Access Compliance Report

Public Rights-of-Way

| Intersection ID: 50119 | Main Street: PARK_SOUTH_STATION_BV | Cross Street: PARK_ROYAL_AV | Location: NE |
| ADA ID: BF7E8F40501E | Curb Cut Type: MedianRefuge2 | Initial Pass/Fail: Fail | Overall Compliance: No |

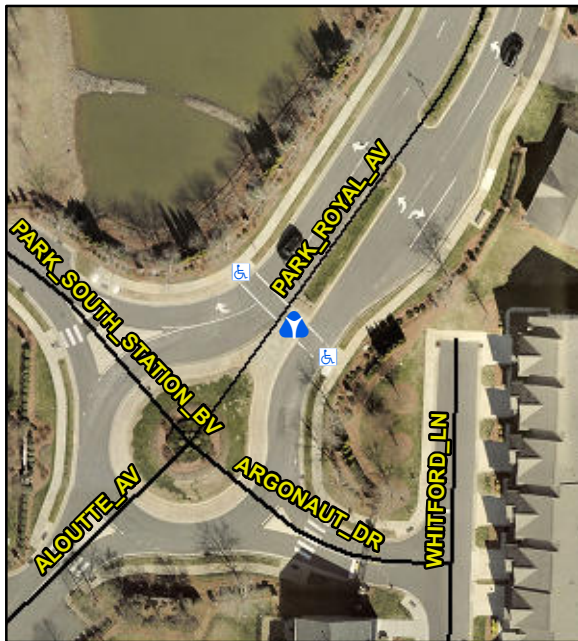
| Compliance | Description | Data | Compliance | Description | Data |
|------------|----------------------|-------|------------|-----------------------------|------|
| No | Refuge 1 Width (In) | 46.5 | N/A | Gutter 1 Lip Ht (In) | N/A |
| No | Refuge 1 Slope (%) | 5.4 | N/A | Gutter 1 Slope (%) | N/A |
| No | Refuge 2 Width (In) | 46.5 | N/A | Gutter 2 Lip Ht (In) | N/A |

Remove & Replace Entire Refuge.
